2.11 Wind Mitigation

S96A Proposal: Changes to soft landscape for wind mitigation.

2.12**Tree Planting**

2.13 Hard Landscape

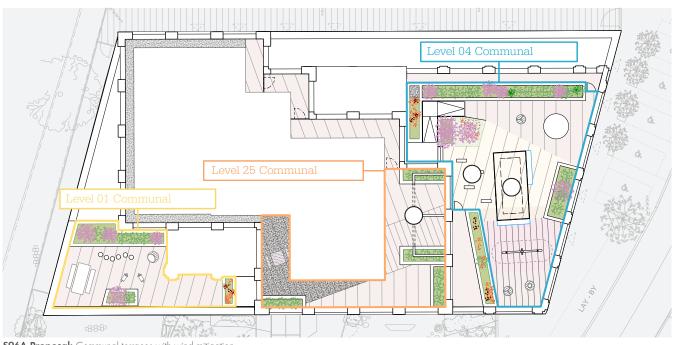
Denotes area requiring improvement to remove wind baffles:

The design of the ground floor landscape has been developed to omit the wind mitigation measures previously proposed.

Additional soft landscaping and tree planting has been added in the required areas to improve the pedestrian environment.

S96A Proposal: Communal terraces with wind mitigation.

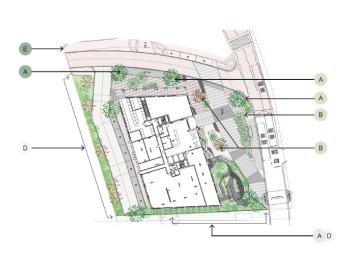
The design of the three communal amenity terraces have been developed to incorporate suitable wind mitigation measures including:

- 1. Pergola structure to level 25 terrace.
- 2. Mirror play walls to level 04 terrace.
- 3. Playhouse structure / shelter to level 04 terrace.
